**SUNDRY NOTICES AND REPORTS ON WELLS**  
*Do not use this form for proposals to drill or to re-enter an abandoned well. Use Form 3160-3 (APD) for such proposals.*

8. Well Name and No.  
FLORANCE D LS 05

Re: Permanent Abandonment  
Well: Florance D LS #5

CONDITIONS OF APPROVAL

# XTO - Proposed P&A Wellbore Diagram

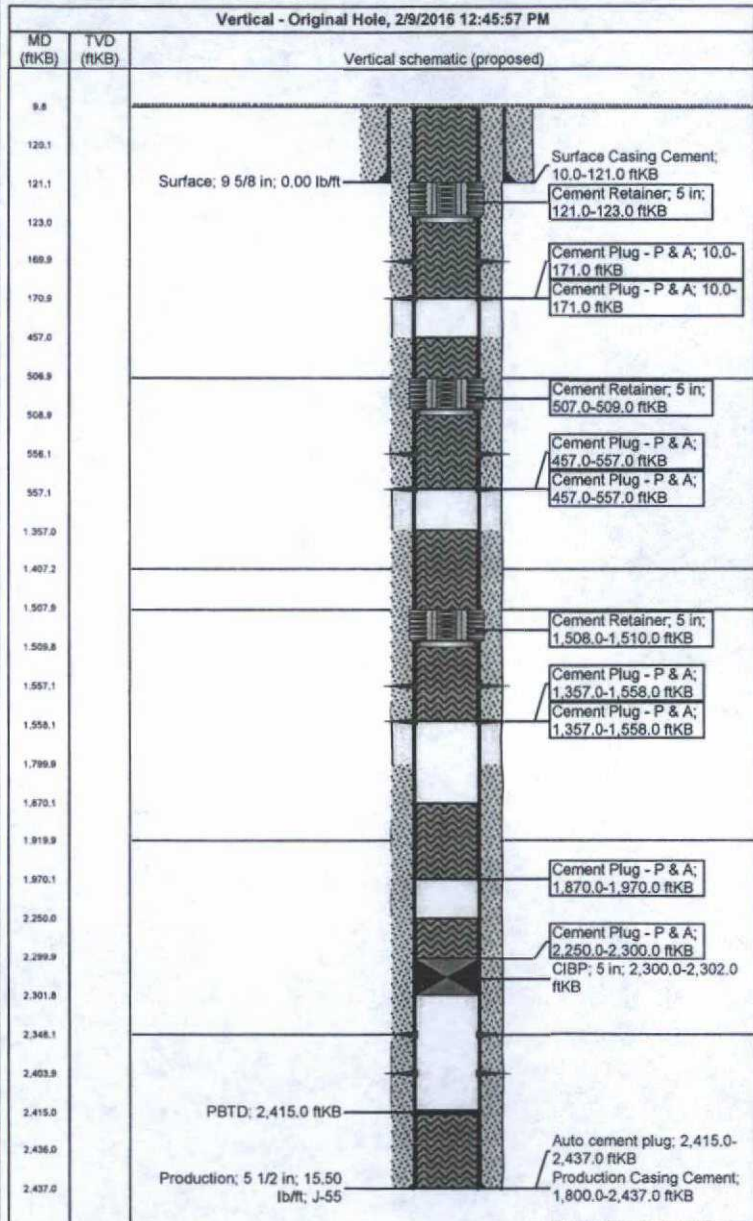
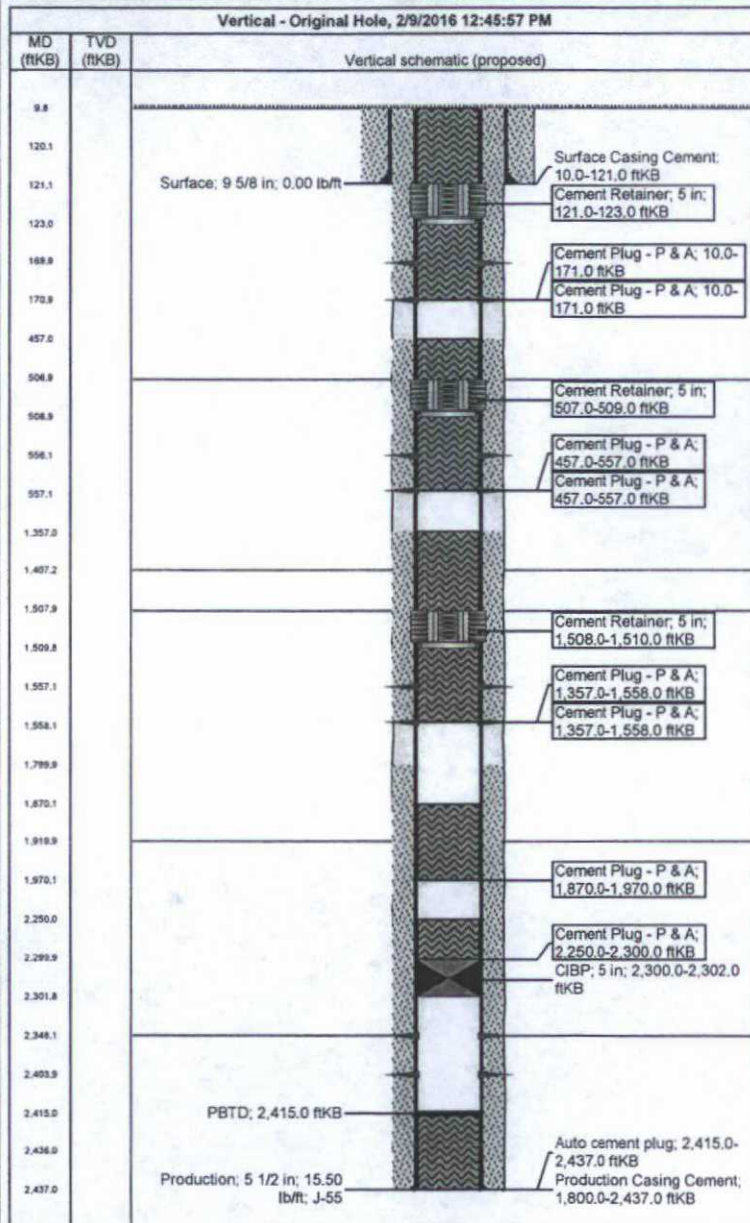
- a) Set Plug #2 (2149-2049) ft. to cover the Fruitland top. BLM picks top of Fruitland at 2099 ft.

Plug #4 is unnecessary. The San Jose Formation is not present in this area.
